Access Compliance Report

Public Rights-of-Way

(Curb Ramps)

Intersection ID: 52924	Main Street: HUGH_FOREST_RD	Cross Street: MAPLE_OAK_DR	Location: E
ADA ID: 789CBD4DF5C0	Ramp Type: Perp	Initial Pass/Fail: Fail	Overall Compliance: No
Severity Score: 8.75			
Codes/Mitigation Info/Possible Solution		Field Measurements/Component Compliance

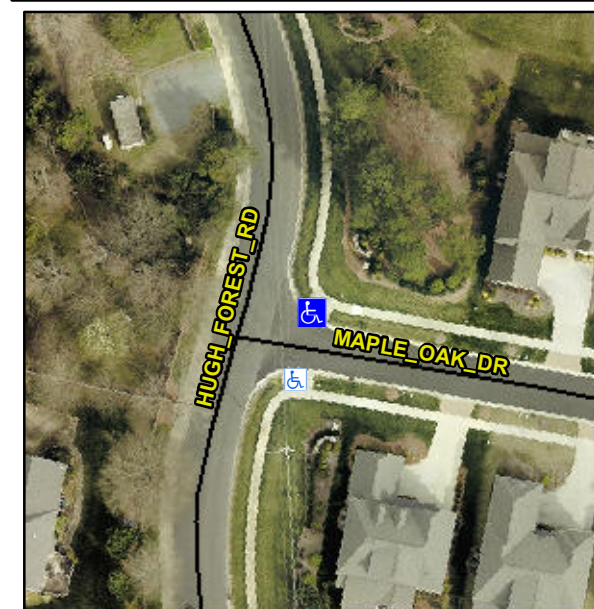
Compliance	Description	Data	Compliance	Description	Data
N/A	Ramp Length (in)	96.0	Yes	Ramp Slope (%)	5.0
No	Ramp Width (in)	41.0	Yes	Ramp XSlope (%)	0.7
N/A	Flare Type LT	N/A	N/A	Flare Type RT	N/A
N/A	Flare Slope LT (%)	N/A	N/A	Flare Slope RT (%)	N/A
N/A	Flare Traversable LT?	N/A	N/A	Flare Traversable RT?	N/A
N/A	Landing Length (in)	N/A	N/A	DWS Provided?	N/A
N/A	Landing Width (in)	N/A	N/A	DWS Contrast?	N/A
N/A	Landing Slope (%)	N/A	N/A	DWS Length (in)	N/A
N/A	Landing X Slope (%)	N/A	N/A	DWS Full Width?	N/A
N/A	Landing Curb? (Y/N)	N/A	N/A	DWS Offset (in)	N/A
N/A	Shared Landing?	N/A			
N/A	Gutter Ponding?	N/A	N/A	Gutter Slope (%)	N/A
N/A	Gutter Lip Ht (in)	N/A	N/A	Gutter X Slope (%)	N/A
N/A	Painted X Walk1?	No	N/A	Painted X Walk2?	N/A
	X Walk 1 Direction	To SW		X Walk 2 Direction	N/A
N/A	X Walk 1 Width (in)	N/A	N/A	X Walk 2 Width (in)	N/A
	X Walk 1 Slope (%)	1.9		X Walk 2 Slope (%)	N/A
	X Walk 1 X Slope (%)	1.7		X Walk 2 X Slope (%)	N/A

Remove & Replace Entire Ramp.
